TMS 402/602 COMMITTEE

Re: Editorial 'No Protest' Ballot – Due May 15, 2022

Attached is a 'no-protest' ballot of 5 items addressing correction issues in the TMS 402/602 document. Since we have previously considered 105 other 'no protest' ballot items, the numbering sequence begins with 106.

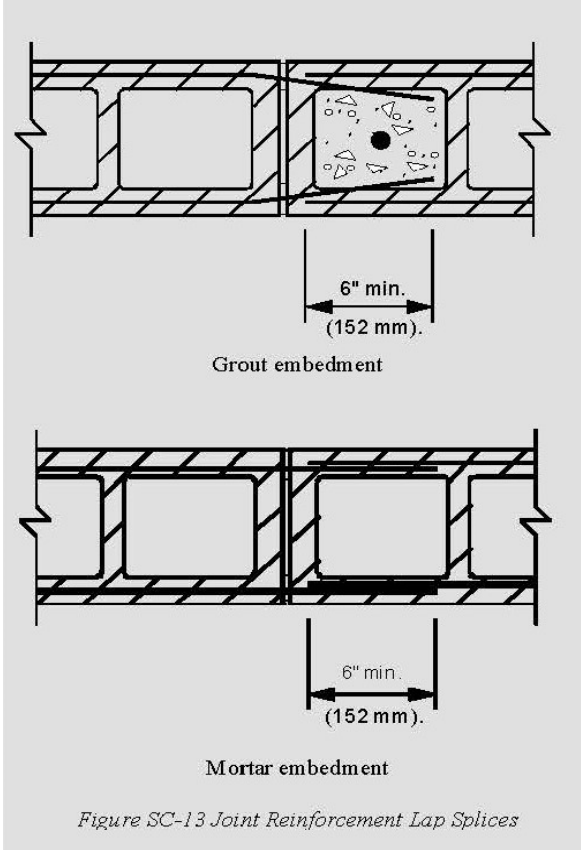
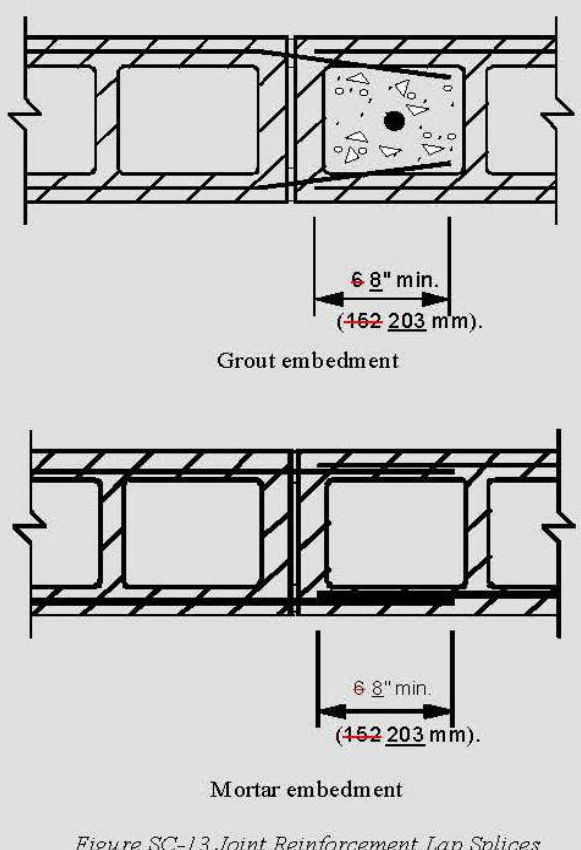
109	Comm Fig SC-13	 <p style="text-align: center;"><i>Figure SC-13 Joint Reinforcement Lap Splices</i></p>	 <p style="text-align: center;"><i>Figure SC-13 Joint Reinforcement Lap Splices</i></p>	Update Commentary Figure to be consistent with Spec Article 3.4 B.11.b which requires 8 inch lap
110	Spec Table 4	<p>1. As masonry construction begins, verify that the following are in compliance:</p> <p>...</p> <p>c. Grade, type and size of reinforcement, connectors, and anchor bolts (References) Art. 2.4 A, D, E, F, G, I, K, & L</p>	<p>1. As masonry construction begins, verify that the following are in compliance:</p> <p>...</p> <p>c. Grade, type and size of reinforcement, connectors, and anchor bolts (References) Art. 2.4 A, D, E, F, G, <u>H</u>, I, <u>J</u>, K, & L</p>	Add missing reference links to required tasks
